Vermont Agency of Transportation
RECEIVED
 CK'D BY Rob Young
 OK'D BY Rob Young
 April 21, 2017
 RESUBMIT NO Approved AsNoted
 BY Rob Young DATE 04/28/2017

CONTRACTORS VISPE:	LEGEND:	PRECAST CONCRETE ABUTMENT SHOP DRAWINGS (SDI JOB #18544)		INSTALLER:	FABRICATOR:
		(A) Oxford A750-7 (B) P52:20T x 10" Lift (C) 4" Pipe (D) 3" Pipe (E) Ø 24" Galv. Corrugated Steel Pipe (F) Ø 15" Galv. Corrugated Steel Pipe (G) Ø 3" x 24" Plastic Corrugated Sleeve (H) P53 Lift w/ Tension Bar (I) 1" Chamfer	SUPERVISOR: E. Barendse DETAILER: I. ADAMS CHECKER: E. Barendse ENGINEER: CONCRETE ENG. SOLUTIONS	PROJ. NAME: HUNTINGTON PROJECT #: BF 0211(32) LOCATION: HUNTINGTON, VT	S.D. IRELAND CONCRETE WILLISTON, VT 05495 Ph: (802) 863-6222 04/20/17

Approach Slab 2B:

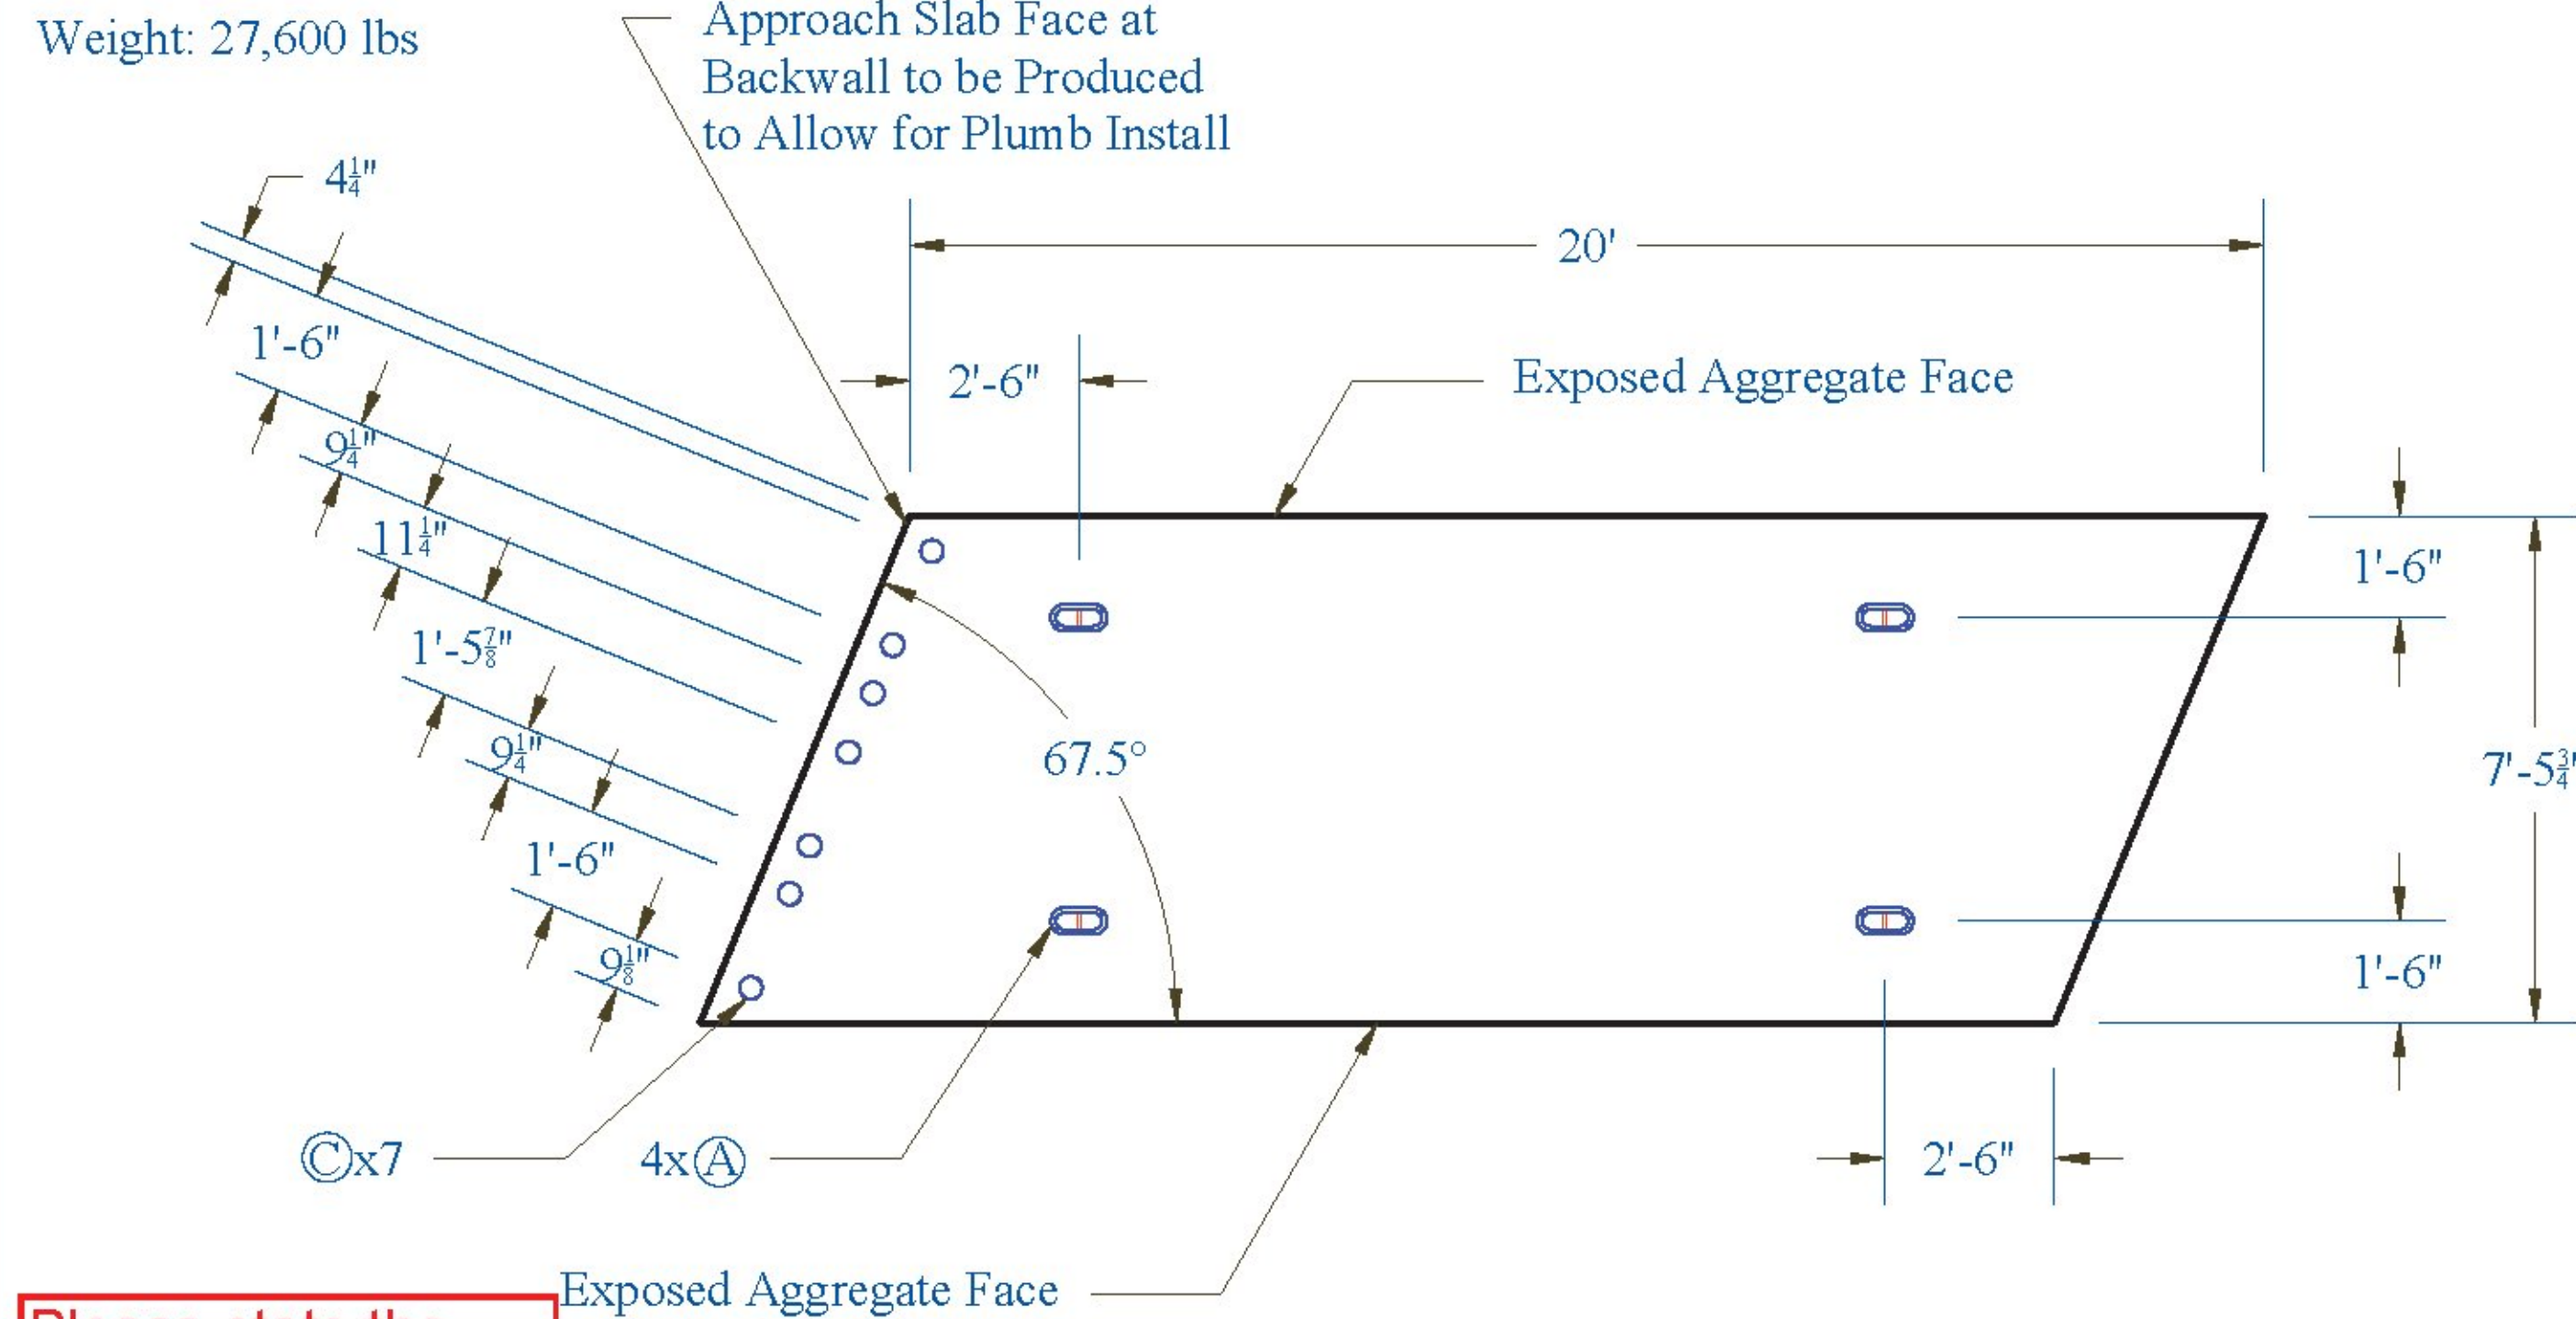
Please state the material, so that it's clear from these drawings.
